**COMMENTS ON THE  
GRPE DRAFT ECE COMPRESSED GASEOUS HYDROGEN (CGH<sub>2</sub>) REGULATION  
Version 10 Dated 06.11.02  
(NON GRPE/ISO HARMONIZATION)**

**GRPE - 004**

2003-01-16

**Table 1: GENERAL COMMENTS**

Figure X: Flex-impulse testing fixture

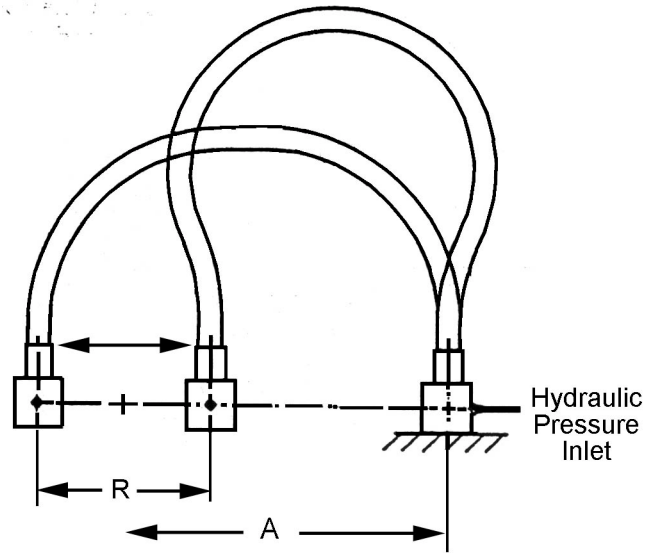
**Replace B5.2.3 with a combined flex-impulse test adapted from SAE J1405.**

### B5.2.3 Flexible Fuel Lines

The length of the flexible part of the *Flexible Fuel Line* with its fittings attached, to be used in the following test shall be calculated as follows:

$$L = 4.142R + 3.57D$$

where:

- L = Length of the flexible part of the *Flexible Fuel Line*
- R = Minimum bending radius specified by the *Manufacturer*
- D = Outside diameter of the *Flexible Fuel Line*

The *Flexible Fuel Line* shall be bent in the manner depicted in Figure X and attached to a fixture in that position by the *Fittings* with which it is to be approved. One end of the *Flexible Fuel Line* shall be attached to a reciprocating manifold and the other end shall be attached to a stationary manifold connected to a hydraulic supply. The *Flexible Fuel Line* shall be pressurised quickly by means of a quick opening solenoid valve, such that one cycle consists of holding the pressure at 1.25 times the *Working Pressure* for  $10 \pm 1$  seconds (except for *Flexible Fuel Lines* with a required material temperature of 120°C where the hold pressure shall be 1.37 times *Working Pressure*) and then reducing it to less than 0.1 times the *Working Pressure* for  $5 \pm 0.5$  seconds. The total number of test cycles shall be equal to 2.0 times the number of *Filling Cycles* or *Duty Cycles* as appropriate to the use of the *Flexible Fuel Line* in accordance with Paragraph 2.4.6 or 2.4.7 of this Regulation as appropriate. 50% of the test cycles shall be performed at the minimum and the remaining 50% at the maximum material temperature in accordance with Paragraph 2.4.5.1 of this Regulation.

Superimposed on the hydraulic pressure cycles is a flexing cycle. The flexing rate shall be  $36 \pm 2\%$  of the hydraulic pressure cycling rate. This assures that the *Flexible Fuel Line* is in a different configuration on each succeeding pressure cycle impulse. The test fixture is shown in Figure X with the distance A calculated as:

$$A = 1.75R + D$$

The *Flexible Fuel Line* shall not show any visible signs of damage.
